CITY OF MARTINEZ

**CITY COUNCIL AGENDA
June 5, 2013**

SUBJECT: Public Hearing to Consider and Possibly Take Action to Adopt a Resolution to Exempt the Project Denial from CEQA and Deny an Amendment to the General Plan and Zoning Map, Planned Unit Development, and PUD Plan and Vesting Tentative Map for development of up to 80 attached single family homes and 2 Single Family homes; 370 Muir Station Road, Laurel Knolls. (Continued from May 15, 2013-public hearing closed).

DATE: June 5, 2013

FIGURE 1 | PROPOSED CHANGES TO PAVEMENT MARKINGS
PEER REVIEW
Laurel Knolls TIA
City of Martinez

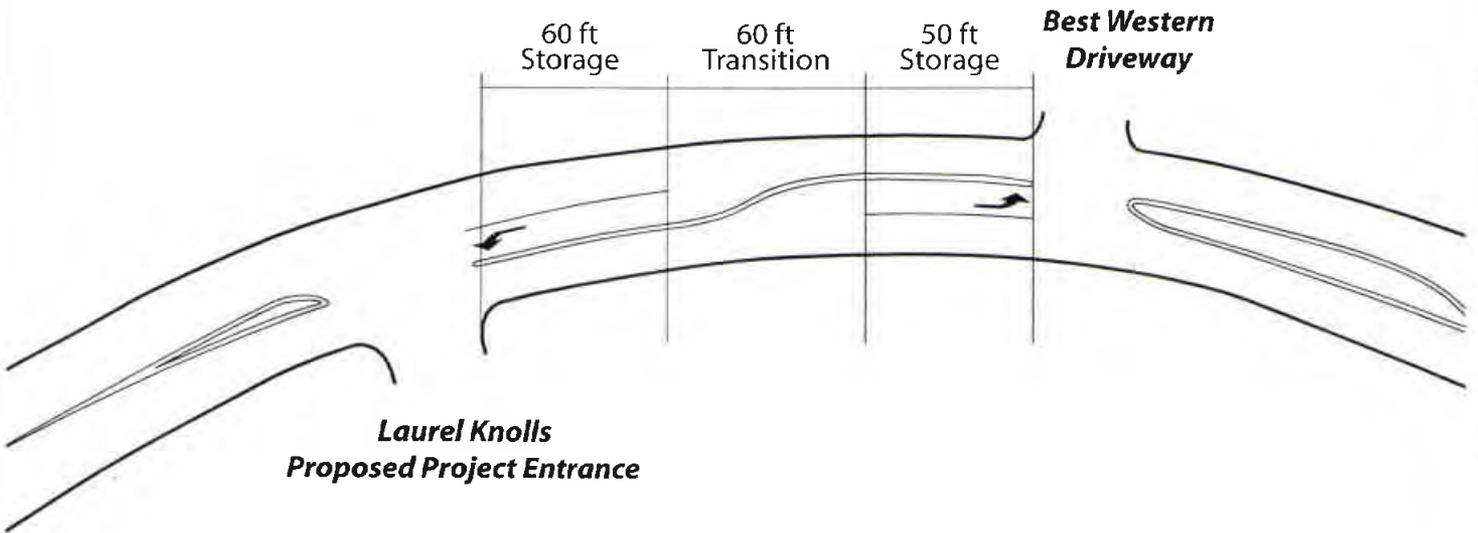
The attached Figure 1 presents the existing conditions and our suggested changes to the pavement markings on Muir Station Road. Please note that we have reviewed the potential queuing for the left turn pockets presented in Figure 1 and the minimum left turn pocket storage of 50 feet (as specified by Caltrans standards) is all that would be required for these two turn pockets. For example, the existing left turn pocket for the left turn from westbound Muir Station Road into the adjacent shopping center has 50 feet of storage and a 40 foot transition.

Section 405.2 of Caltrans' Highway Design Manual specifies that the storage length at an unsignalized intersection "*may be based on the average number of turning vehicles likely to arrive in a 2 minute period.*" Based on the maximum hourly volumes forecast to use the two turn pockets (as presented in Figure 1) the proposed storage for two cars (50 feet) is the most that will ever be needed. Again, it is important to note that the existing two-way left turn lane should continue to operate safely and no changes are required to accommodate project traffic. However, we would suggest the City consider making the changes to the pavement markings shown in Figure 1 if the proposed project is approved.
